SIDE-POWER

COUPLER UPGRADE PRODUCT SHEET 125MM SIZE

Kit Contains the following – picture is of the Standard Kit:

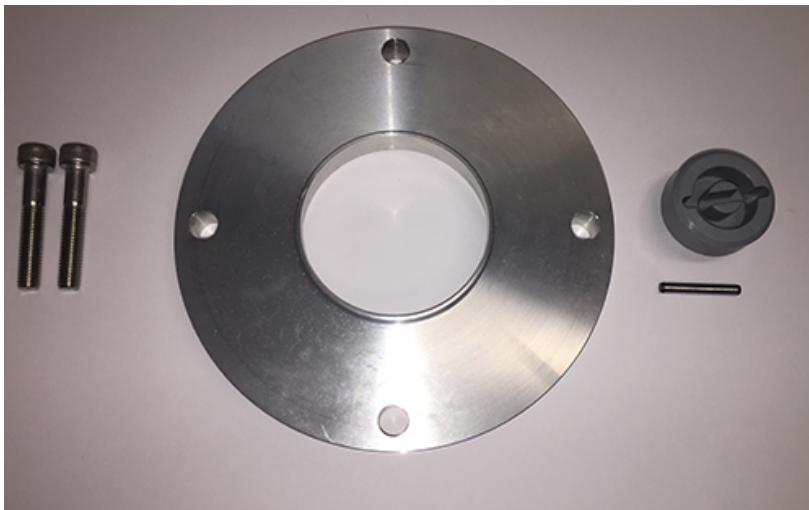
In 2018, Side-Power upgraded all shearpin drives to a new flex Coupler drive. This improvement required a change to the Motor Mount Bracket or Saddle. It had to become a little taller (15mm) to provide a larger cavity to accept the new drive connection.

The New Coupler will allow for a couple of degrees of misalignment. So, if you see adverse Shearpin wear due to alignment being off (grinding the shearpin and metal filings) and the Shearpin potentially failing prematurely, the new Coupler could be a solution.

Basically, the Adapter Plate gets added to provide that additional spacing needed for the new Coupler.

*This Kit uses the same Adapter Plate but replace the two bolts with two 8mm studs and Loctite in place, as longer bolts would have interference from IP Housing. This will make the install and removal of motor easier, as you have studs to "place" the motor onto.

- 1 x Adapter Plate with centering ring
- 2 x New longer motor mount bolts
- 1 x New Flex coupler & Drive Pin

- 1 x Adapter Plate with centering ring
- 2 x New longer mounting studs *not shown
- 1 x Single use blue Loctite *not shown
- 2 x SS Hex Nuts, Flat & Lock Washers *not shown
- 1 x New Flex coupler & Drive Pin
